Haweswater Aqueduct Resilience Programme - Proposed Bowland Section

Supplementary Environmental Information Report

Project No: B27070CT
Document Title: Proposed Bowland Section
Supplementary Environmental Information Report
Document Ref.: LCC_RVBC-BO_SEI
Revision: 0
Date: February 2022
Client Name: United Utilities Water Ltd

SCALE 1:2,000	SHEET SIZE A3
DRAWING NUMBER LCC_RVBC-BO-FIG-006-005-AD1	REVISION 0

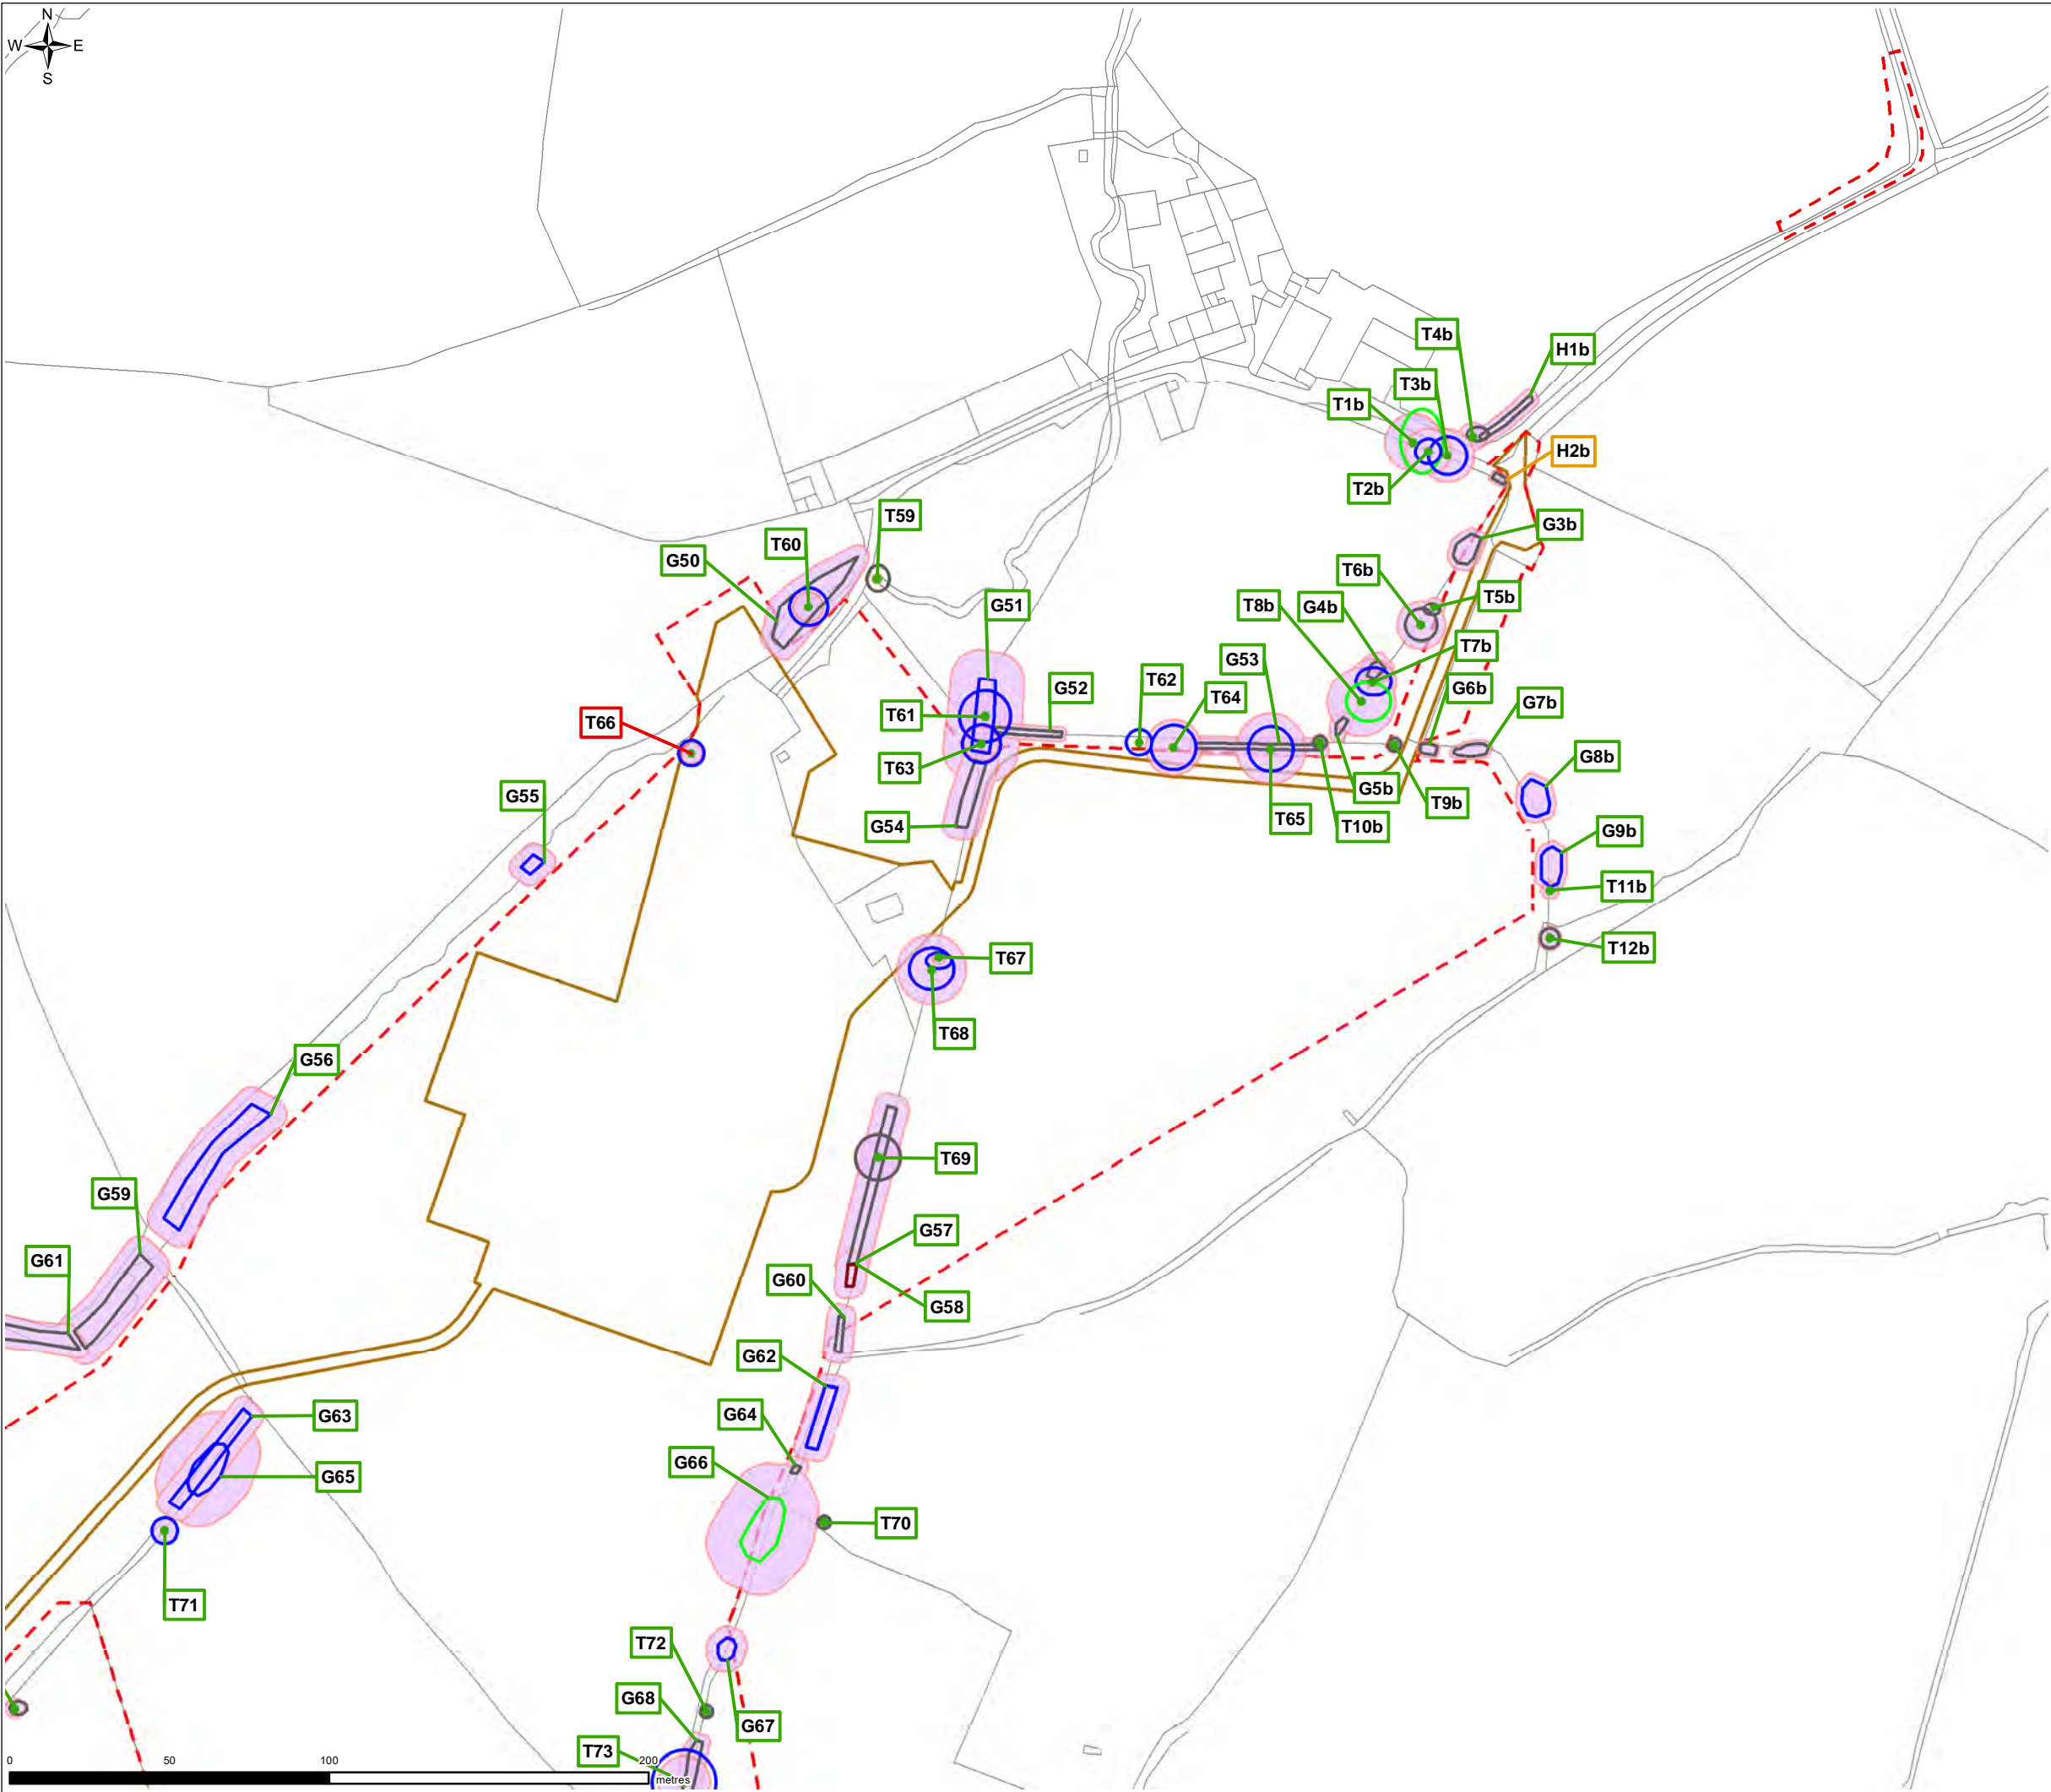
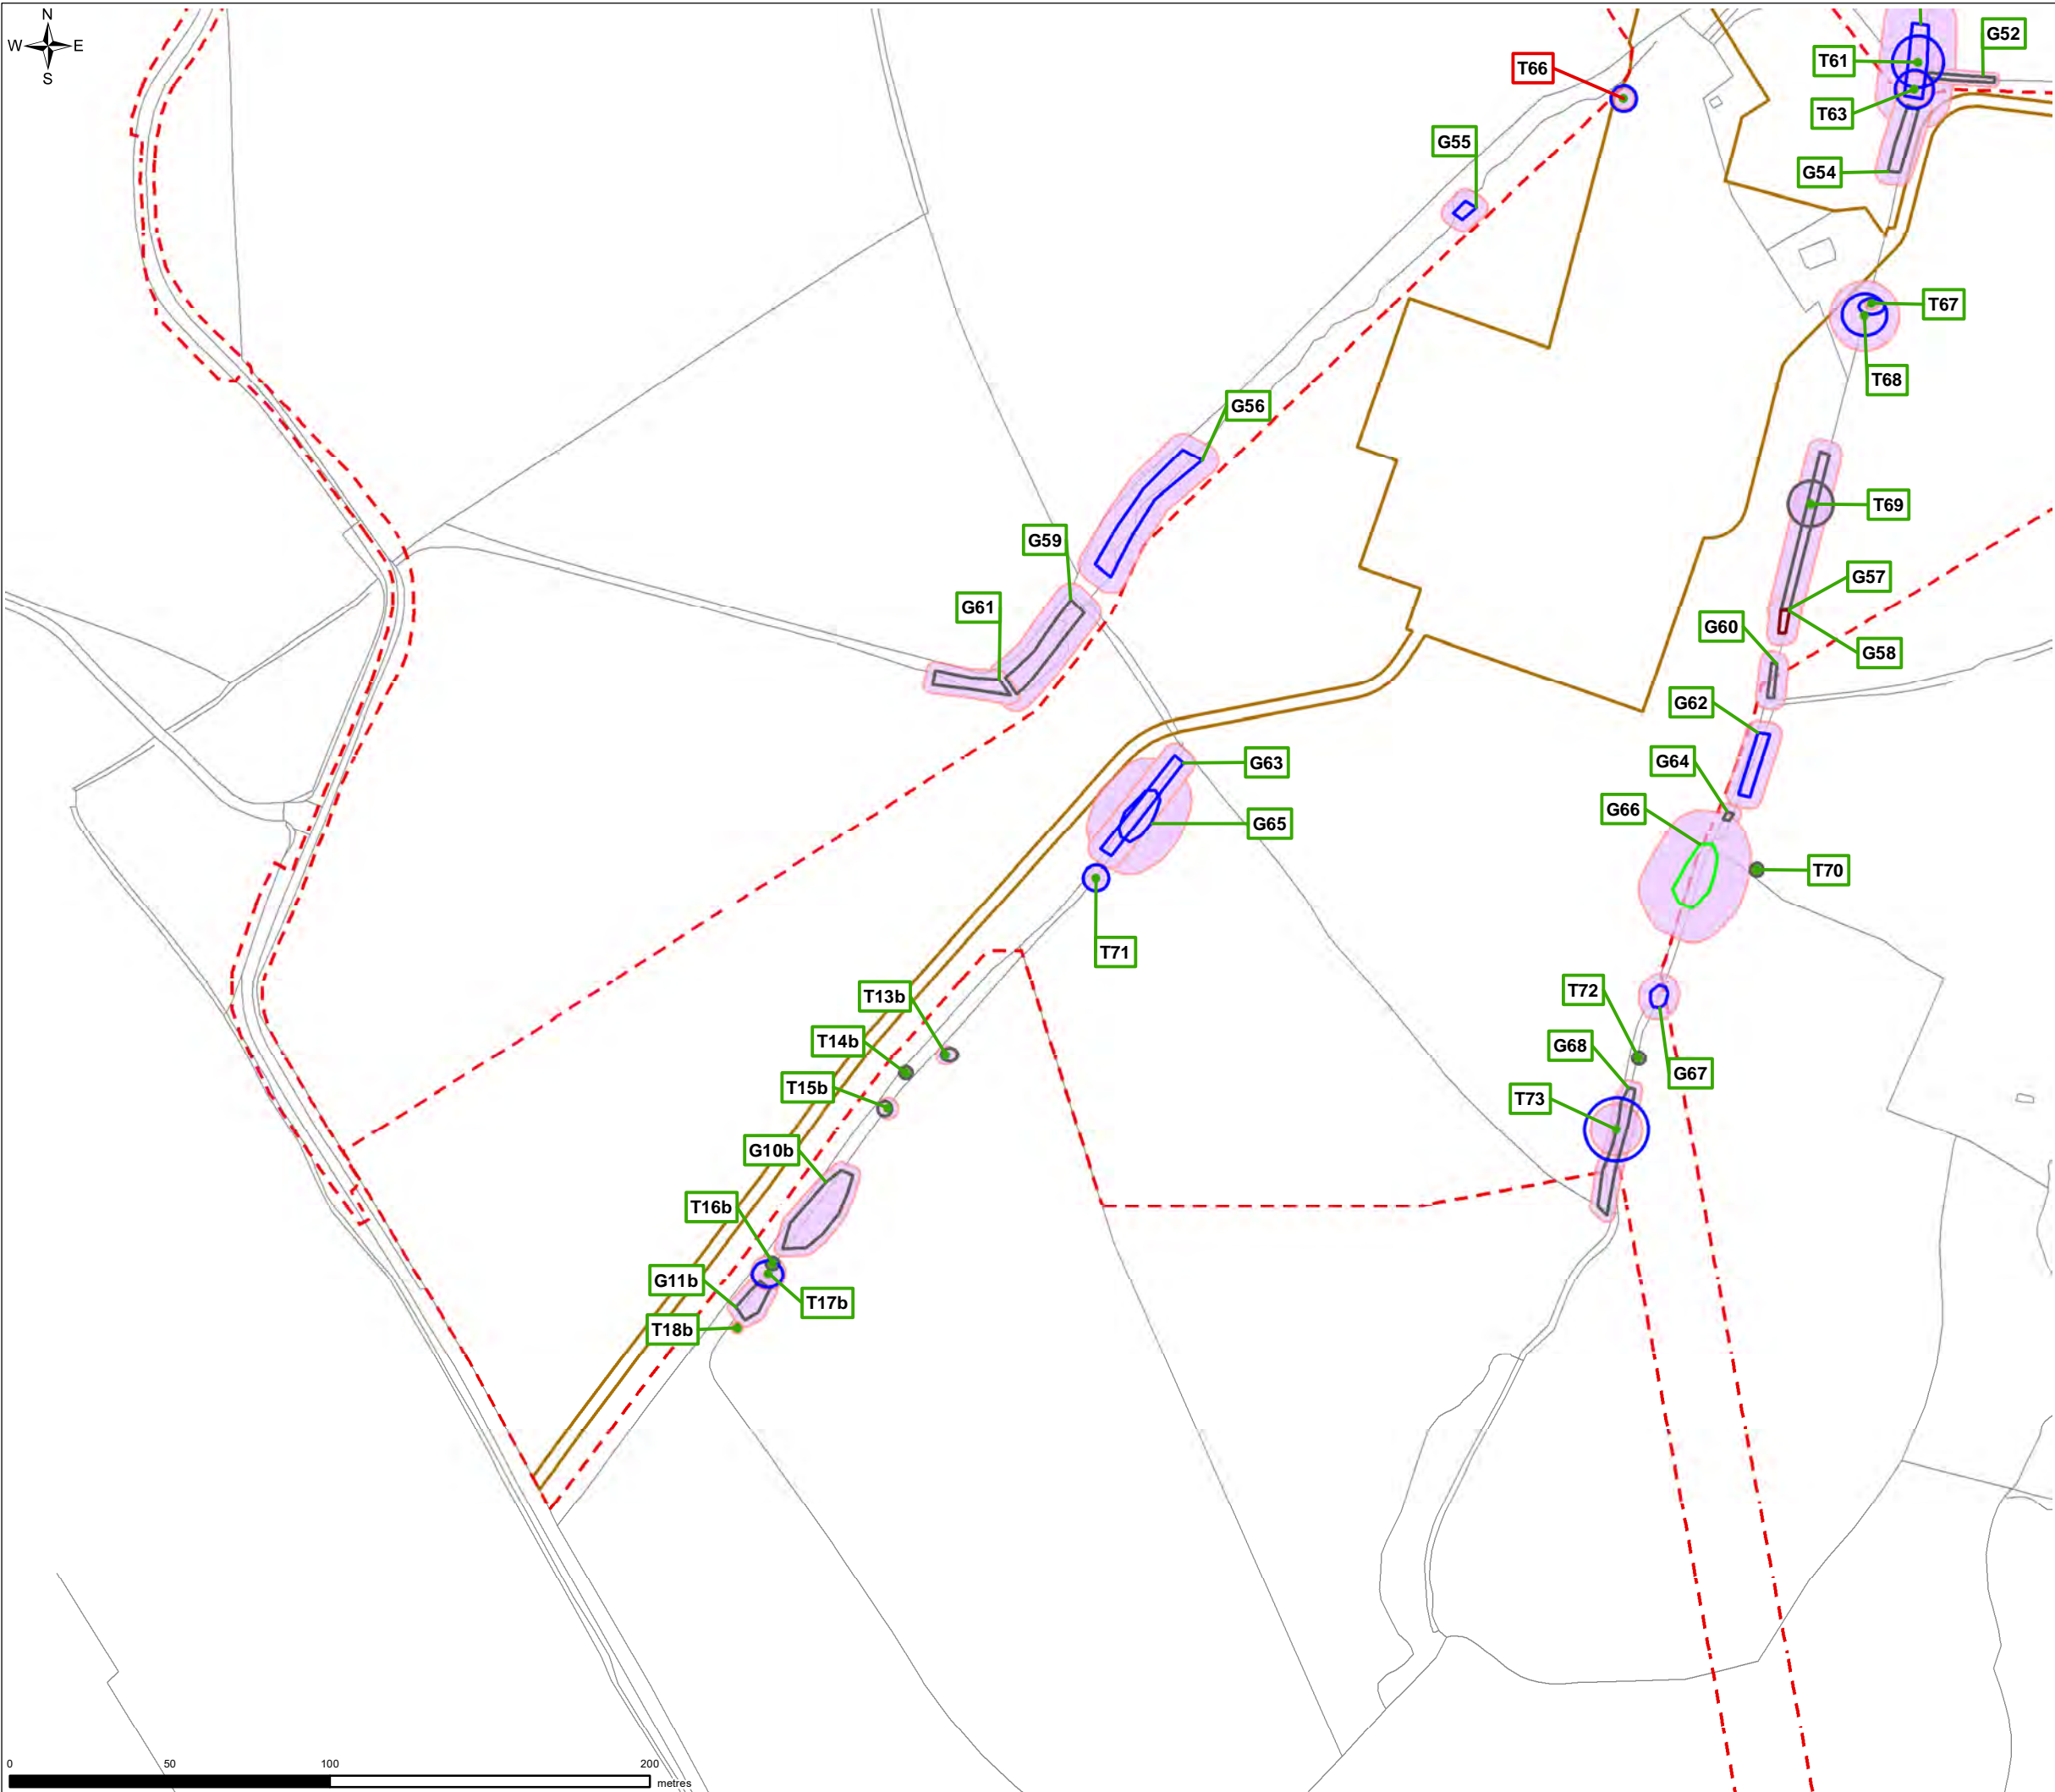
- 49) The updated associated Tree Constraints and Assessment Plans (LCC_RVBC-BO-FIG-006-005-AD1) contain information on tree feature locations and their RAG assessment impacts. The update to the Preliminary Trees at Risk Plan (LCC_RVBC-BO-FIG-006-006) shows the extent of potential tree loss, trees at risk and tree retention within the planning application boundary.
